INDESIT company

Model type:
AVL105SK

Commercial code:
F030206

Fig. n10402231

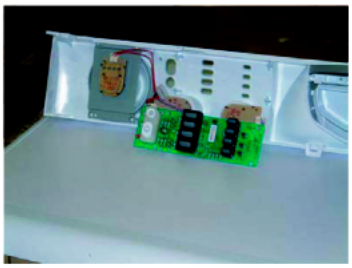
From serial no. 40429.0001, models AVL, AVXL, AVSL, AML have been equipped with a new panel with well holes for the ON/OFF and RESET buttons and flush plastic light diffusers in place of the projecting siliconed ones (see picture n10402231 Fig.02). These features determine whether an appliance is modified or premodification.
The modification has also involved the electronic card whose panel and display communication connectors are on the left and not at the back (see picture n10402232 Fig.2).

For both models
C00143338 - LED CARD EVOII AVL /BUILT-IN ARISTON
C00110115 - WHITE BUTTONS ON-OFF/RESET EVOII LED KIT
C00109854 - PANEL WIRING LBE EVOII
C00110055 - SILICONED BUTTONS AVL-AVSL
C00110059 - PANEL WIRING -DISPLAY 240000848B2.
C00111227 - WIRING MAIN - DISPLAY 24000084804B1 (POLARIZED).
The new parts are only interchangeable with the pre-modification ones if used altogether. They are not individually interchangeable.

Fig . 001

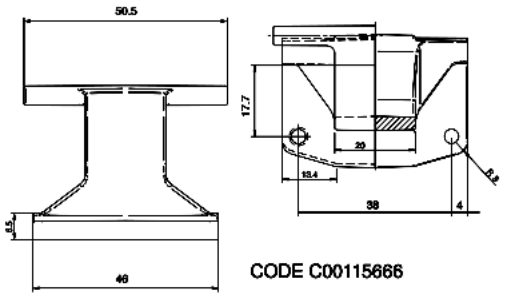
From serial no. 50207.0001, all Ariston models produced in the Teverola factory (see table 001 attached) with industrial code (given on the rating plate) starting with 46, have been equipped with a Zamac hinge with 150° opening angle, code C00115666 (see Fig.001).
This modification has involved the introduction of the following items:

Code C00115670 - Complete door EVOII 150° white 27 with standard glass;
Code C00115674 - Complete door EVOII 150° white 27 with long glass;
Code C00115667 - EVOII body for 150° hinge white 27;
